00900  
ADDENDUM NO. 3

**NEW GARAGE BUILDING FOR:**  
**THE GARRARD COUNTY COOPERATIVE EXTENSION SERVICE**

All bidders must acknowledge this addendum in the "Form of Proposal." The proposed contract documents are modified as described in the following. This addendum shall be a part of the Contract Documents.

SHEET NO.  
A-2

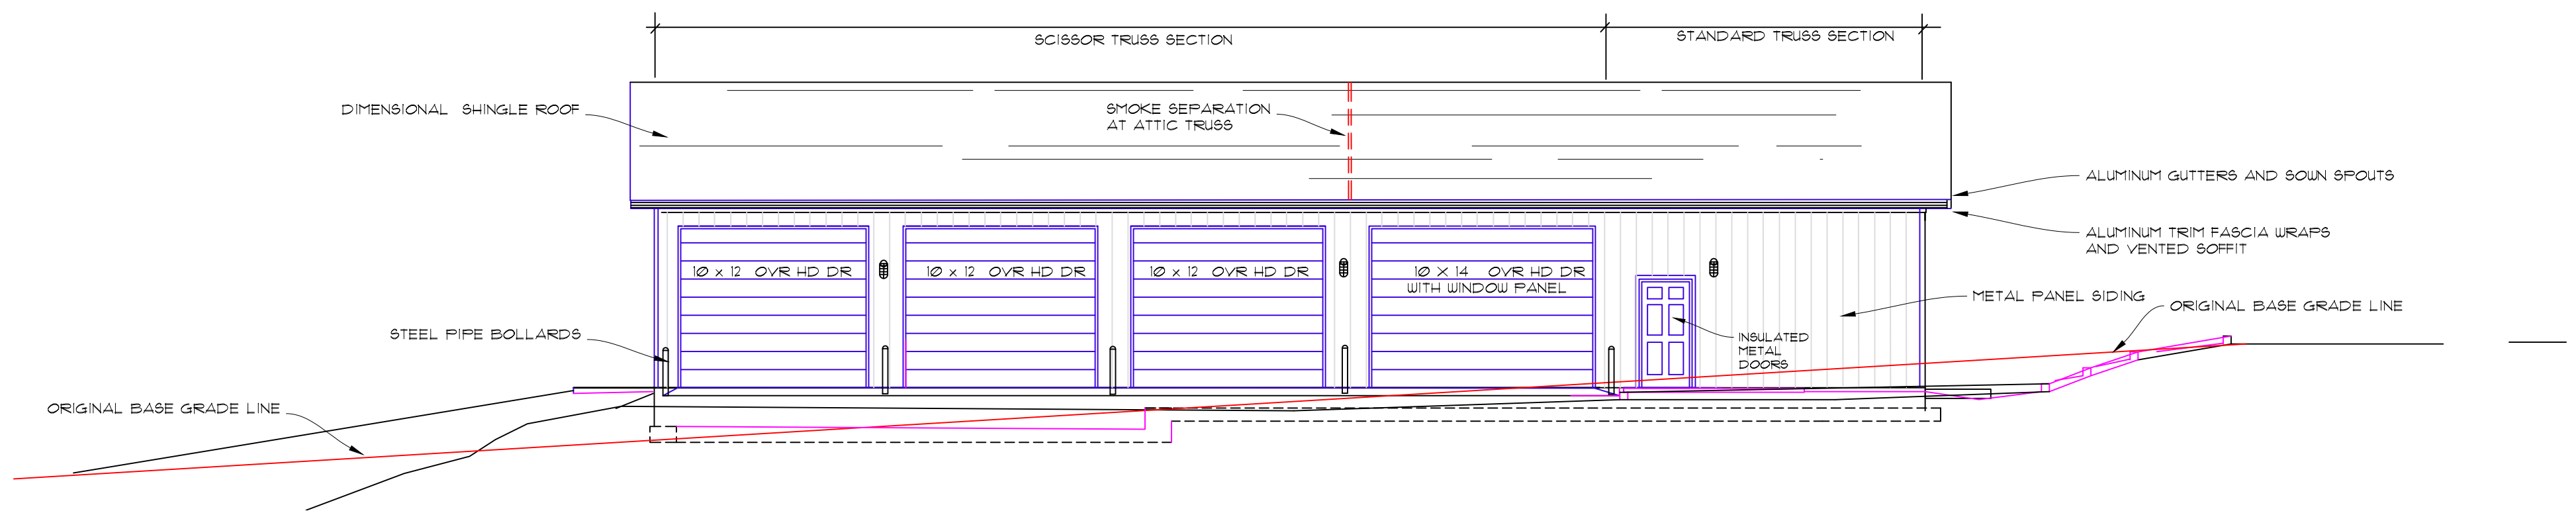
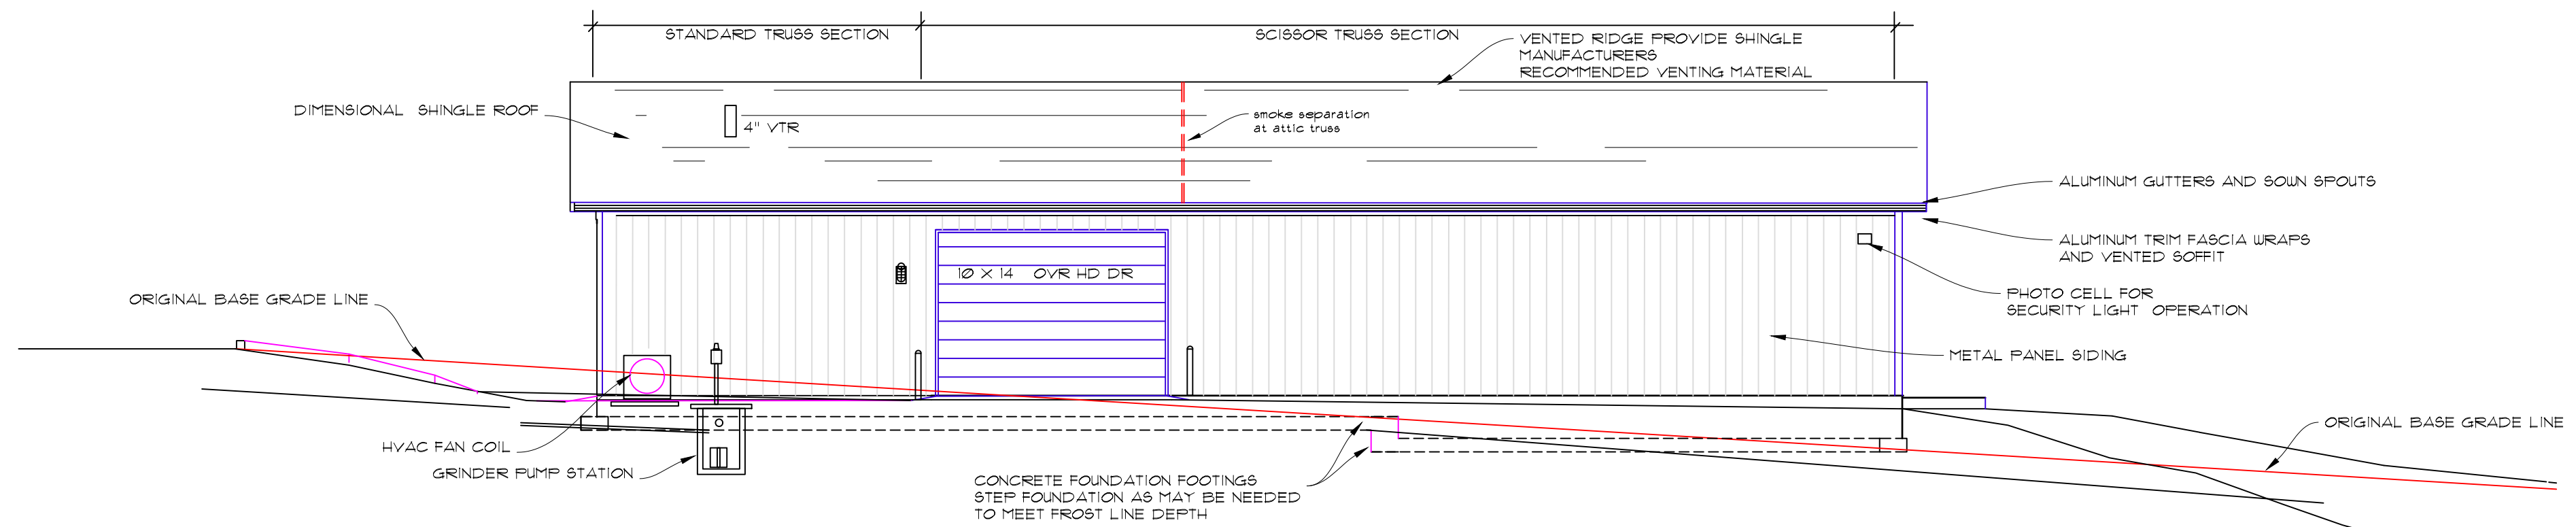
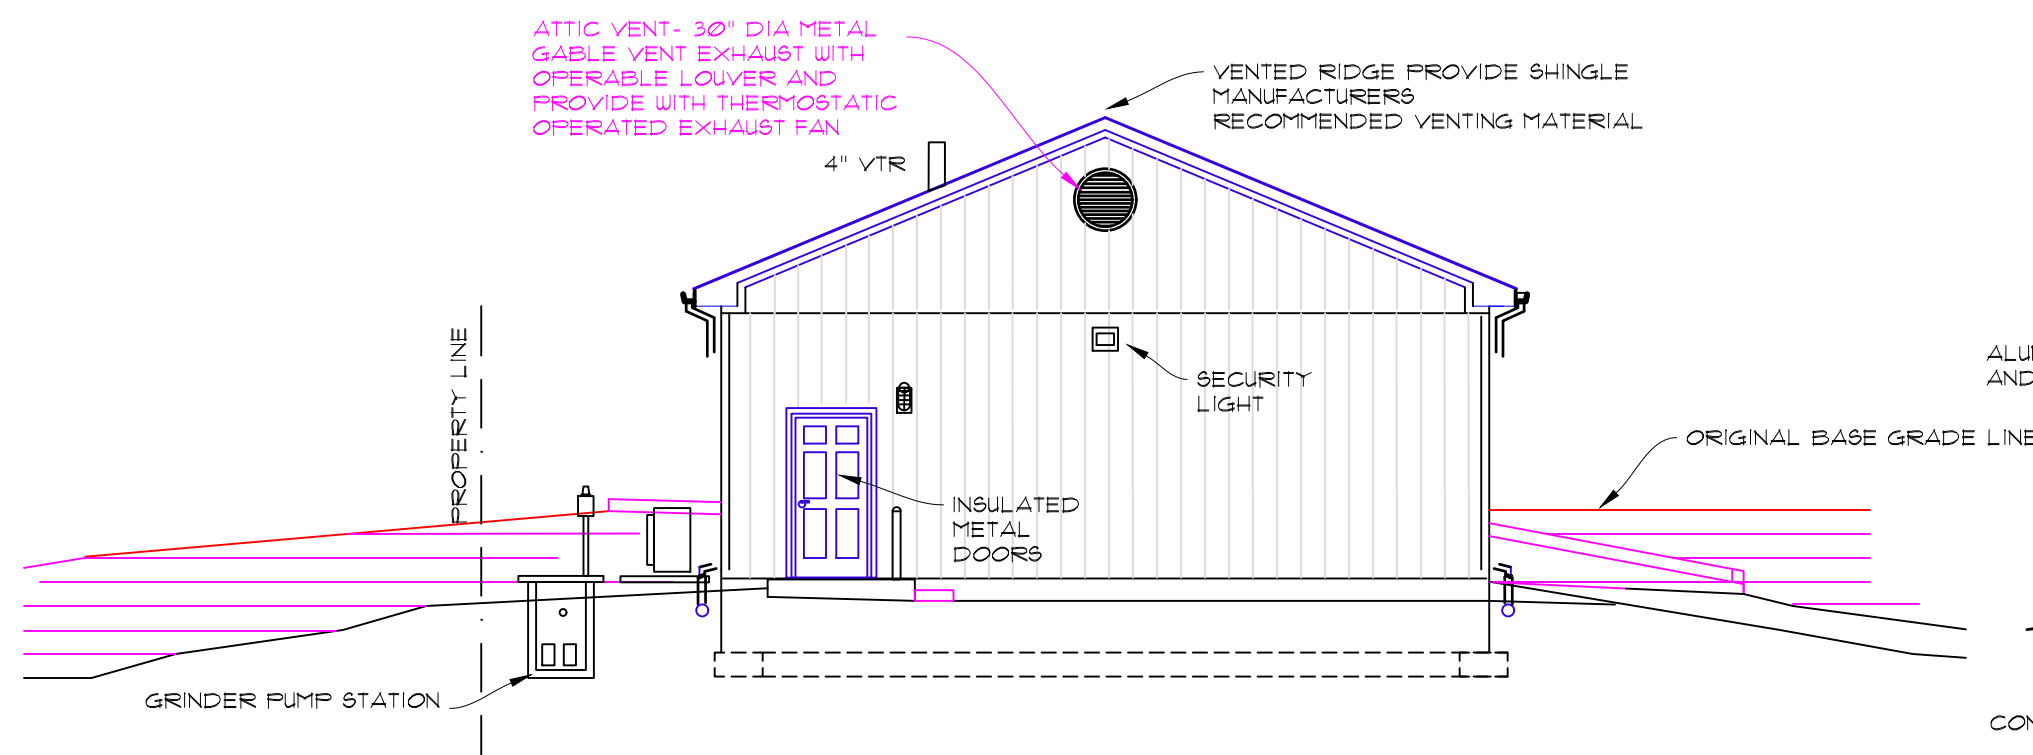
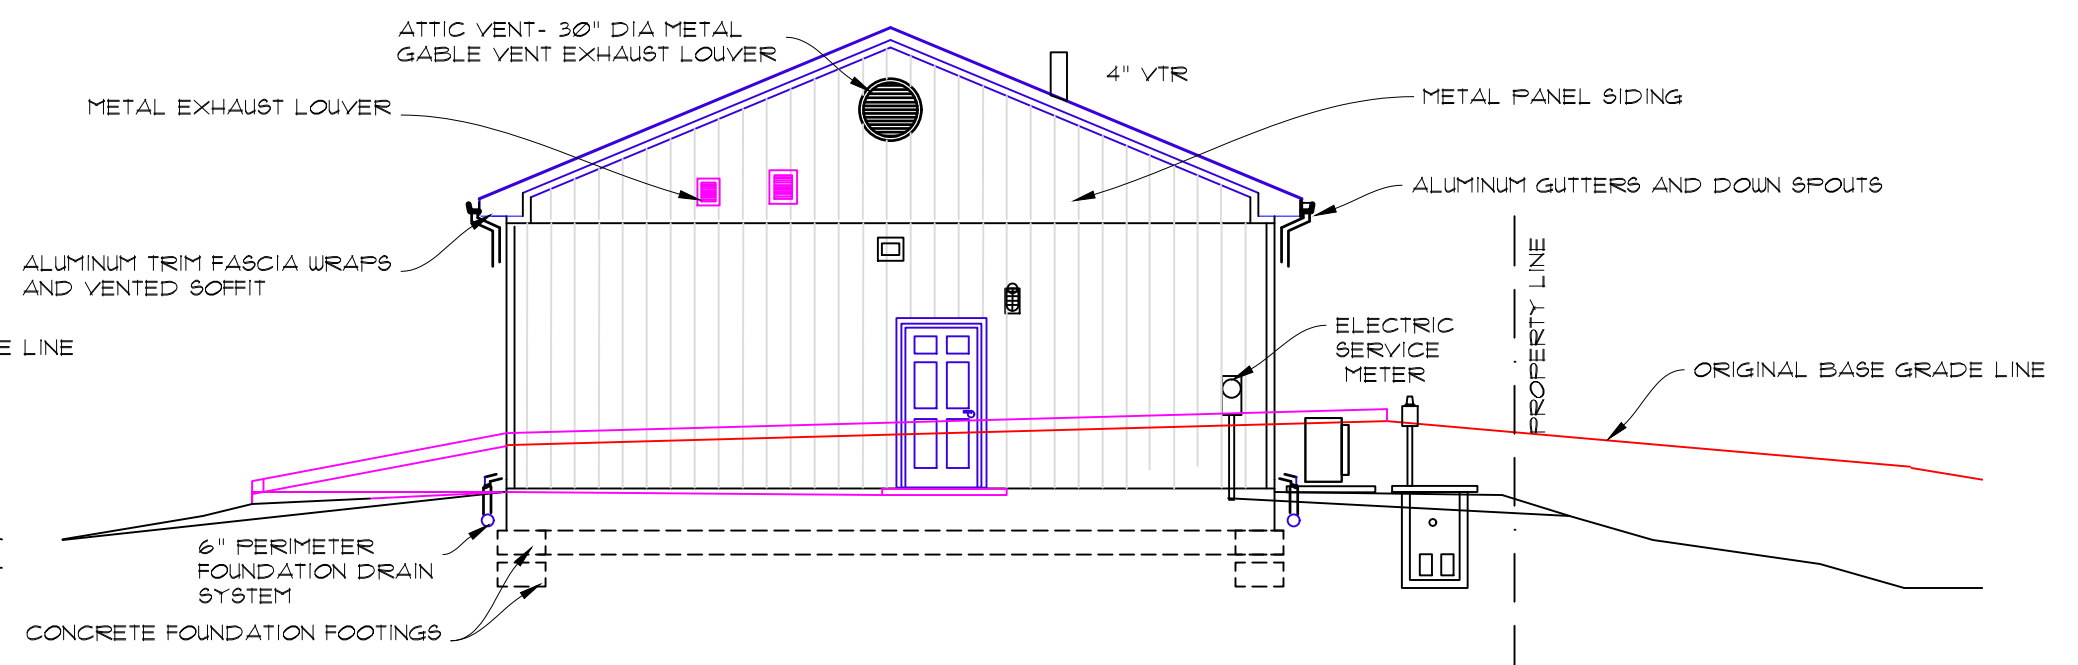
3.16 Elevation Sheet A-2; Reference this revised drawing sheet dated  
4/23/25 for up-dated information.

Notable- Omitted windows from the wet bay garage door.

Exhaust fan on South Elevation.

Lifted and added exhaust fan louver on North  
Elevation
